ORDINANCE NO. 1764

KLUMPP PUD (2nd) AMENDMENT

DATE: November 28, 2022
TO: Fairhope City Council
FROM: Hunter Simmons, Planning Director
RE: Klumpp PUD (ZC 22.04)

ZC 22.04 - Klumpp PUD Amendment

OVERALL SITE PLAN

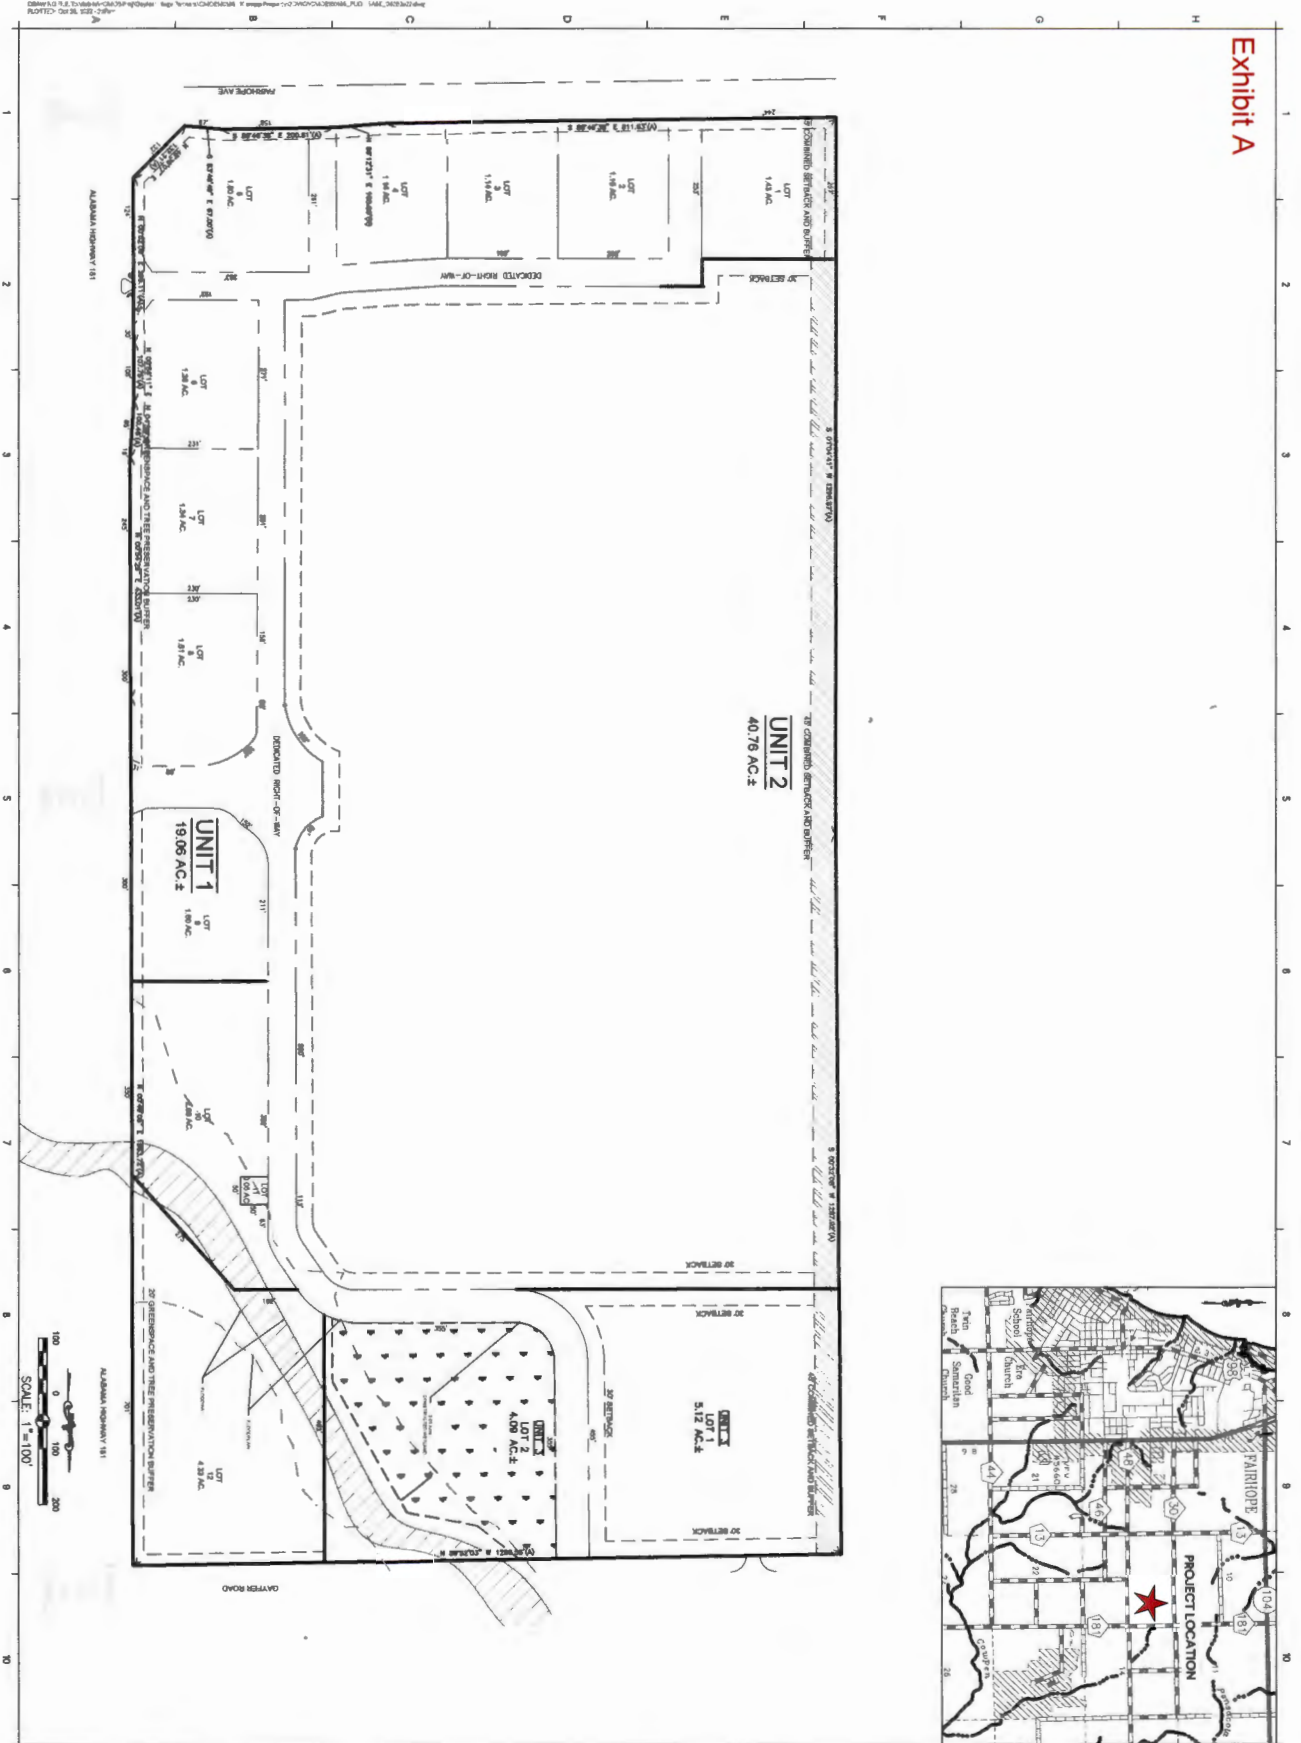
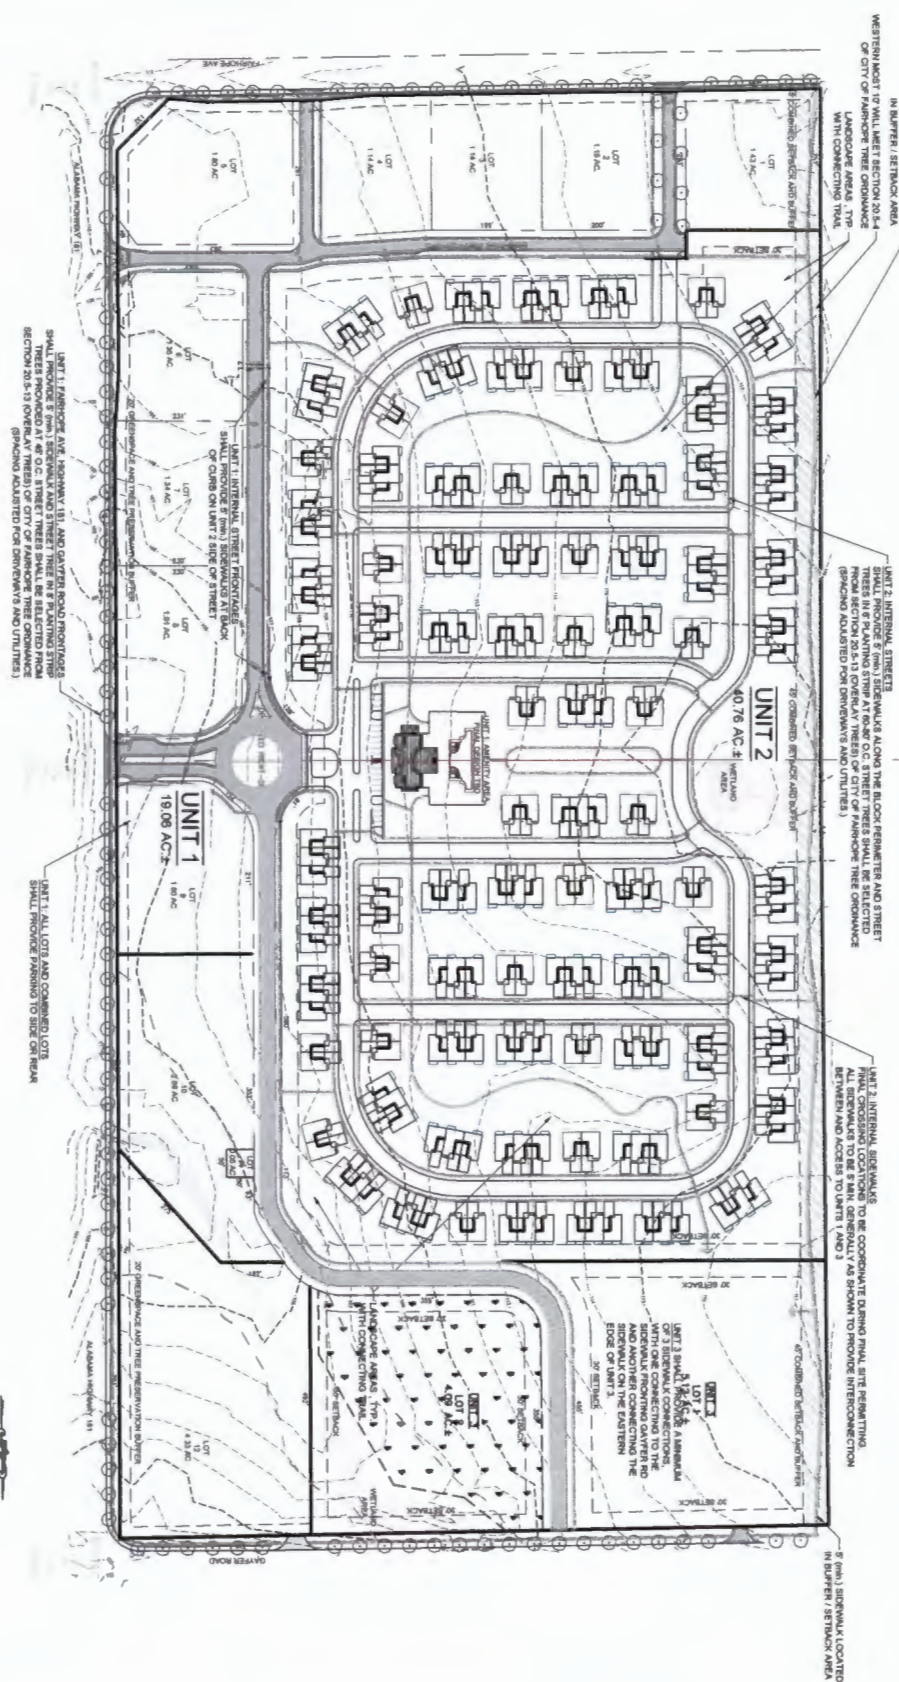
The layout of the roads were revised to provide connectivity to Gayfer Avenue Extension as shown on Exhibit A attached hereto.

Lots: The lot count remains the same. The lot layout has been amended as shown on Exhibit A attached hereto.

Acreage: Unit 2 was reduced from 41.03 acres to 40.76 acres as shown on Exhibit A attached hereto.

Lots: There shall be two (2) lots.

Dimension Standards: The setbacks, building height, and lot coverage for Lot 1 shall be per the R-3 requirement. The R-3 minimum lot width shall not apply, and the lot dimension shall be as shown on Exhibit A attached hereto.

Figure 1: Existing Site Plan

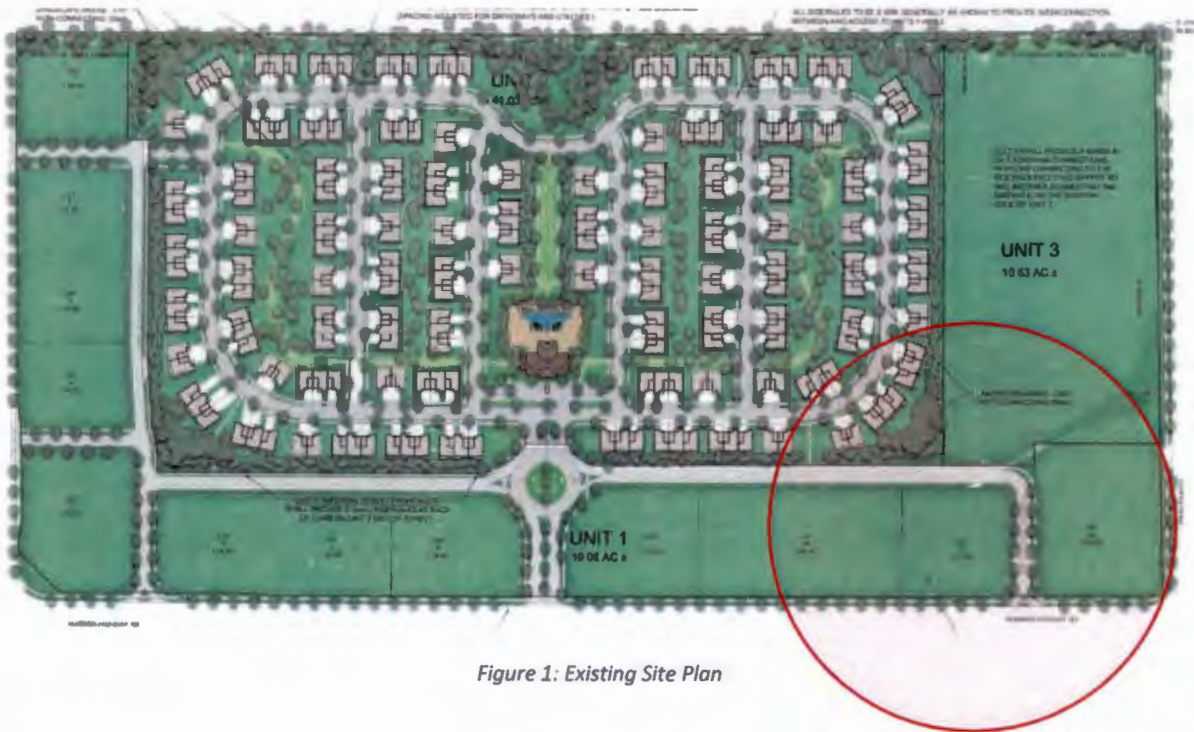
The main reason for the currently proposed PUD amendment is to remove a portion of road through wetlands, providing connectivity between Units 1 and Unit 3 and an optional ingress/egress to Hwy 181, as illustrated on the following plans.

Figure 1 below is the existing (approved) site plan. The area circled in red emphasizes the area revisions are proposed. As seen in Figure 2, the proposed road ends at commercial lot 10. Since our last review of this project, the applicant has worked with the Corps of Engineers with potential designs for a road within both the natural wetlands and the constructed wetlands. Ultimately, they now request not to install the road.

As proposed, lot 12 will require ingress/egress from either Gayfer Ave or Hwy 181. Unit 3 will only have access from Gayfer Ave. Uses within Unit 3 are limited to convalescent, nursing, or assisted living home. With the proliferation of low-speed vehicles, i.e. 'golf carts', and considering connectivity to Unit 3 has been reduced, staff would like to see a solution in the preliminary plat that would allow residents of Unit 3 to access the commercial lots with a low-speed vehicle. One such option is to upgrade the trail on the west side of the property, but the Commission/Council may wish to discuss in more detail. Neither Fairhope Ave, Gayfer Ave, nor Hwy 181 are safe alternatives for low-speed vehicles.

7. Construction of sidewalks shall be done at the time of development of the internal roadways.
8. Revision of the site plan to allow a connection to Gayfer Avenue through Unit 3.

Figure 3: Existing Lot Layout

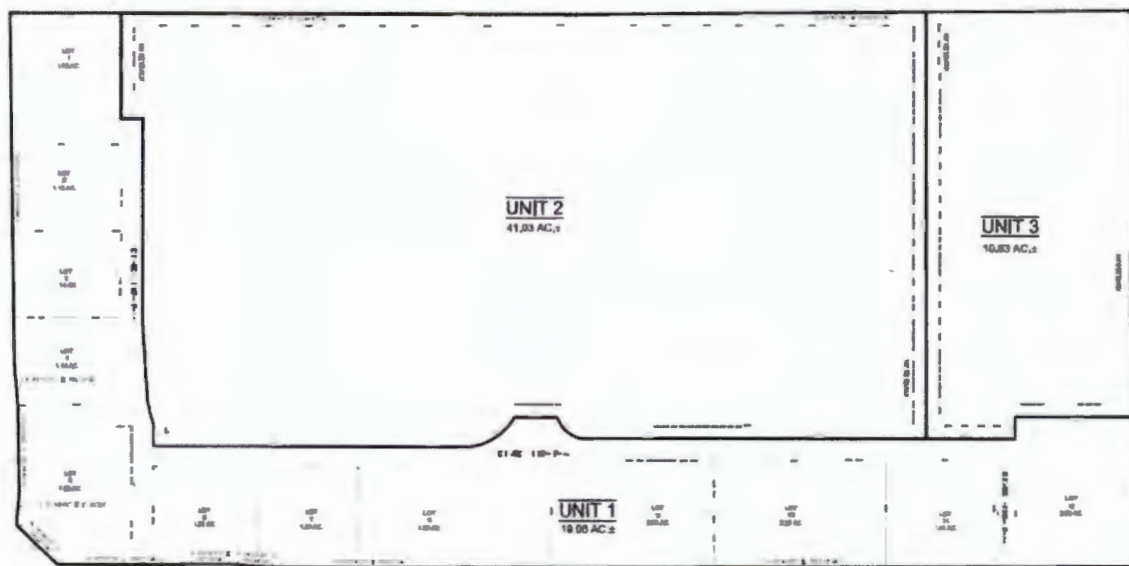
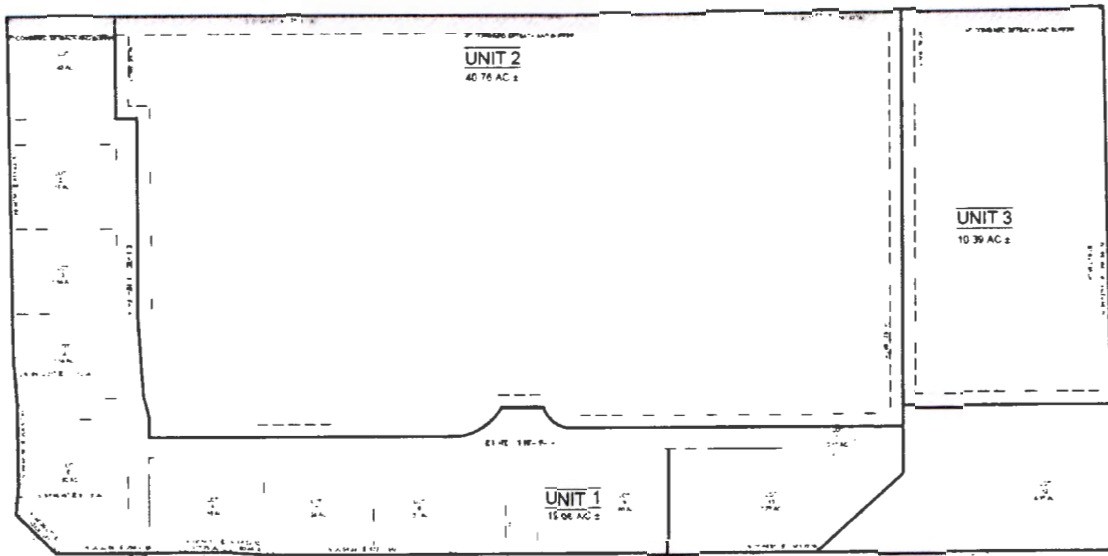
The requested amendment is not changing any uses or previous conditions of the approved PUD. The only change is in the design of the road, which prompted different lot shapes and sizes for lots 10, 11, and 12; and a slight reduction in size of Unit 3 from 10.63 acres to 10.39 acres. The existing lot layout is shown in Figure 3 below. The proposed changes to the lots are illustrated in Figure 4.

OVERALL SITE PLAN

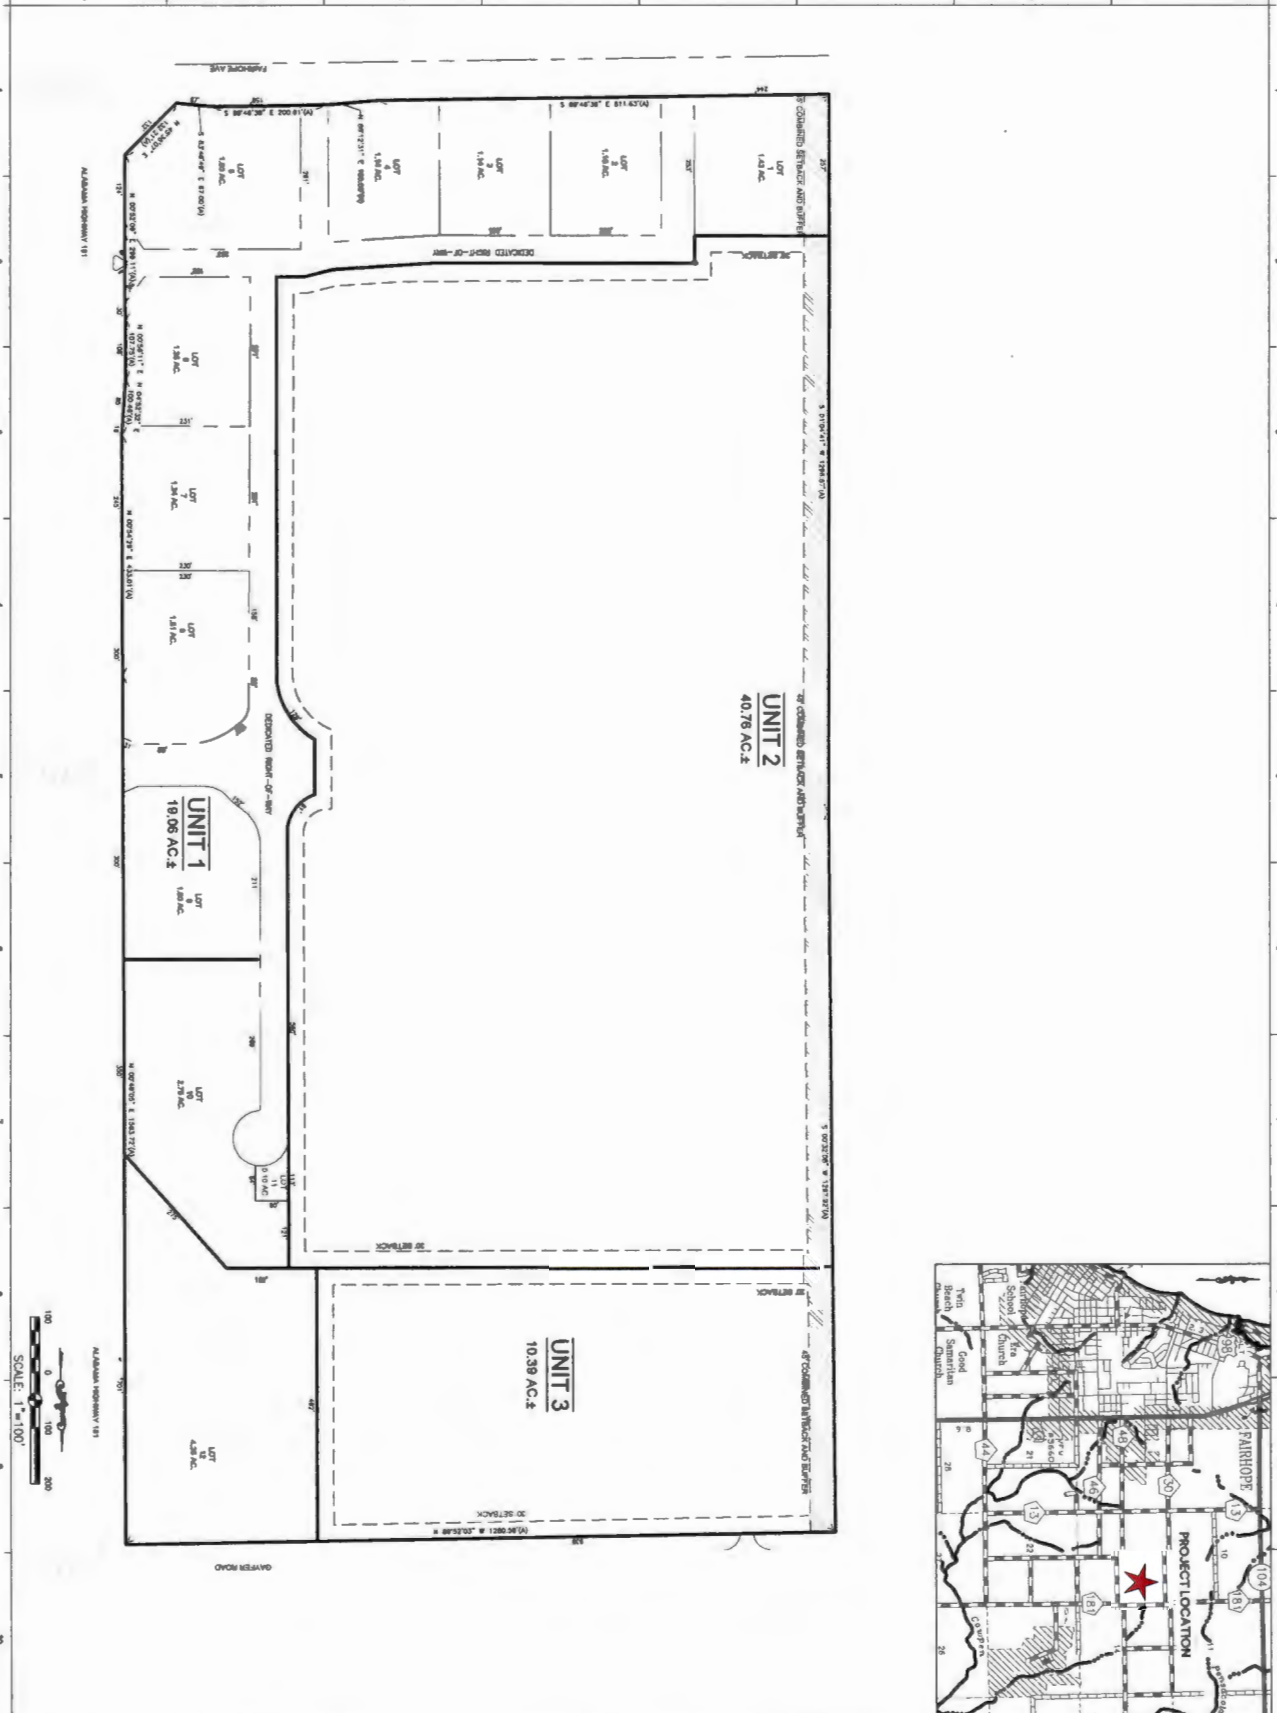
1. We have stopped street B short of Cowpen creek and we are now showing a cul-de-sac south of the creek. After multiple permit submissions to the USACE it was apparent to us that they didn't want us to cross the creek with improvements.
2. This change has resulted in shifting the lot lines associated with Unit 1 Lots 10-12 and Unit 3 Lot 1. We are not creating any more new lots, we are simply shifting the lot lines to better align with the new road configuration.

1. The road way was terminated south of Cowpen Creek and a roundabout is being shown. No work is being shown in the floodway associated with Cowpen Creek and therefore a No-Rise certification isn't required at this time.
2. The northern connection to HWY 181 has been removed.
3. The constructed wetlands has been moved to sit entirely on Unit 3 Lot 1.
4. The pump station has been relocated to Unit 1 Lot 11. At the time of project acceptance Lot 11 will be deeded over to the City of Fairhope.
5. A revised Master Drainage Plan has been attached reflecting the changes to the road and lot layout.

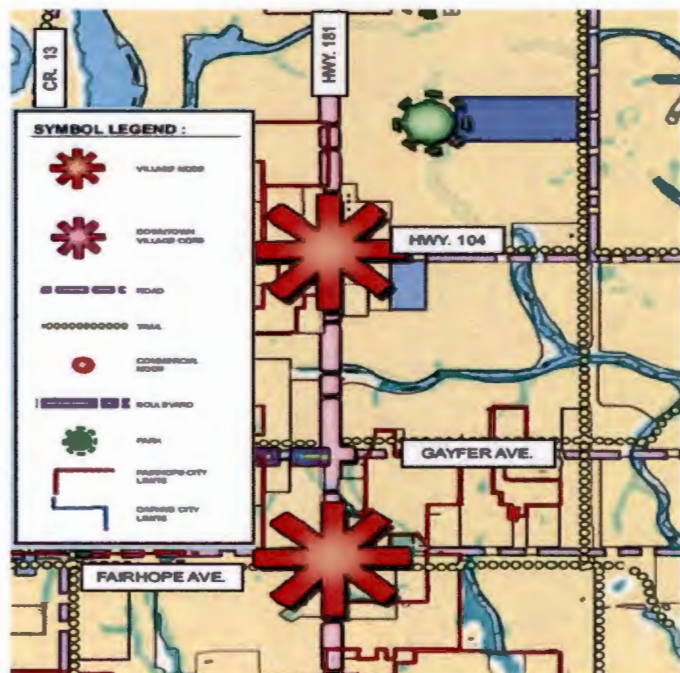
Unit 2, for example, should not require a future Site Plan review. It is feasible to include a comprehensive site plan (for Unit 2) as part of this PUD process with landscape plans, architectural examples, etc., and, at the least, include pedestrian circulation for the entire PUD. It would also be prudent to include guidelines for the Units 1 & 3 to ensure they are developed consistent with Fairhope’s Comprehensive Plan, which may include build-to/setback lines, landscape buffers, planned green space, plant selections, etc.

Unit 2 is now proposed as illustrate on C2.01 and includes up to 233 units. Sidewalks were provided within Unit 2 and the westernmost buffer was increased to 45', which now includes a sidewalk connecting all three units with both Fairhope Ave and Gayfer Rd. Within the 45' buffer, the westernmost 10' will be planted to provide a buffer/screen consistent with the City of Fairhope Tree Ordinance. Street Trees will also be planted in accordance the City of Fairhope Tree Ordinance.

Staff does have some concern that some conflicts exist between retention/detention, possible wetlands, and greenspace requirements within Unit, but those are not part of this review. Unit 2 will require a site plan review as well as an MOP review in the future to resolve the above-referenced concerns. Staff recommends a condition of approval to memorialize the 20% greenspace per density shown and urge that retention/detention should not be placed where greenspace is currently shown unless installed as an improved amenity, such as accessible ponds with landscape consistent with the City of Fairhope Tree Ordinance.

1. A master drainage plan shall be prepared for the entire site and included with the initial subdivision application creating units 1-3
2. City of Fairhope site plan review (Zoning Ordinance Article II, Section C.2.) shall be mandatory for each lot within units 1-3.
3. City of Fairhope subdivision regulations (including multiple occupancy project provisions as applicable) shall be required for the creation of all lots and units within the Klumpp PUD.
4. A 20' greenspace and tree preservation strip shall be provided along Hwy 181.
5. Unit 2 will require 20% greenspace as shown. Provided retention/detention shall not encroach into required greenspace other than those methods approved within the City of Fairhope Subdivision Regulations and/or as approve during MOP/Site Plan Review.
